# Local Planning Panel

13 Brodrick Street, Camperdown

D/2019/663

# proposal

# height

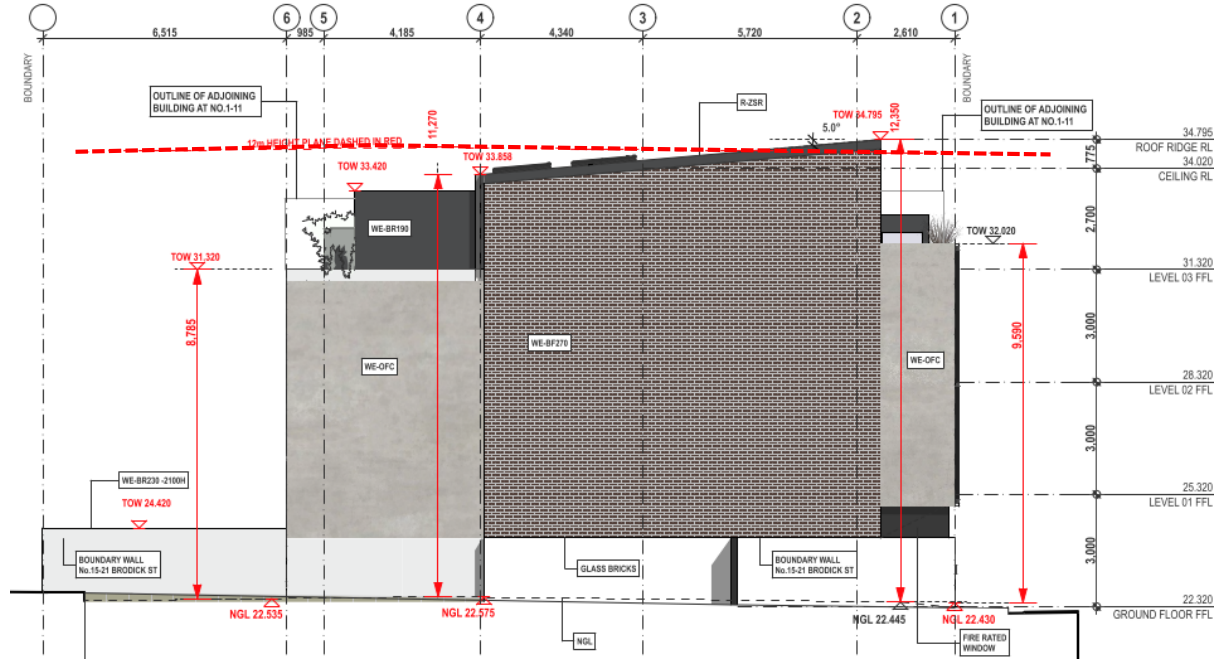
- height control exceeded by 790mm - 6.6% non compliance
- clause 4.6 variation request supported:
  - appropriate built form, building achieves appropriate transition between existing neighbouring buildings
  - consistent with the objectives of the height of building standard and the mixed use zone
  - no significant impacts arising from non compliance

non compliance indicated by a red dotted line

# motor cycle parking

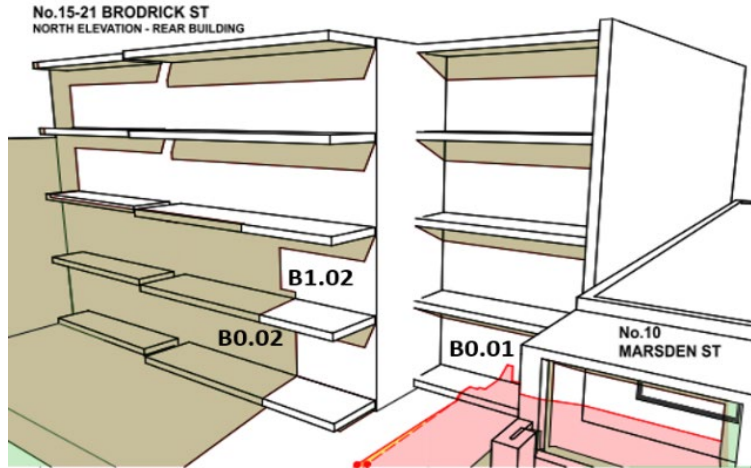
- no motorcycle parking is provided - 2 spaces required - 100% departure from standard
- clause 4.6 variation request supported:
  - site is accessible by public transport
  - additional bicycle parking proposed
  - provides improved street frontages on a small site which would otherwise be required to accommodate driveways/ramps
  - there are no demonstrable adverse environmental impacts arising from an absence of motorcycle parking spaces

JUNE-21-2PM

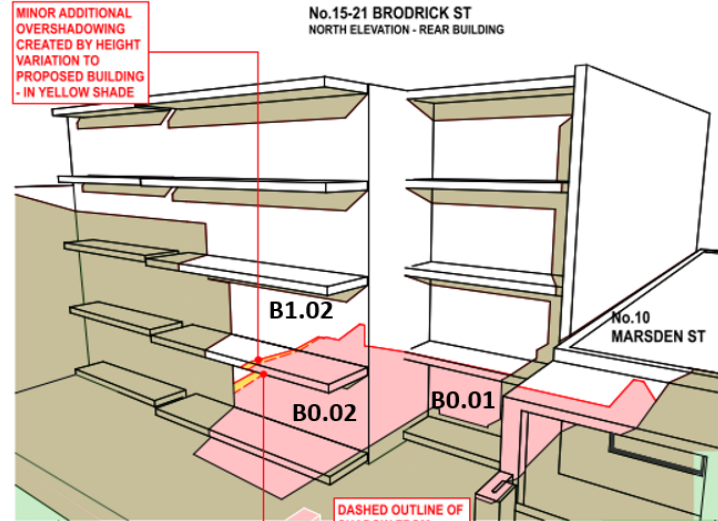
- 15-21 Brodrick Street
  - additional shadows cast on the northern facade between 2pm and 3pm
  - non-compliant part of the building will overshadow less than 0.5sqm area of the balcony of unit B0.02, which would still receive solar access to 50% of its windows

MINOR ADDITIONAL  
OVERSHADOWING  
CREATED BY HEIGHT  
VARIATION TO  
PROPOSED BUILDING  
- IN YELLOW SHADE

DASHED OUTLINE OF  
SHADOW FROM  
PROPOSED BUILDING  
WITH COMPLIANT  
BUILDING HEIGHT
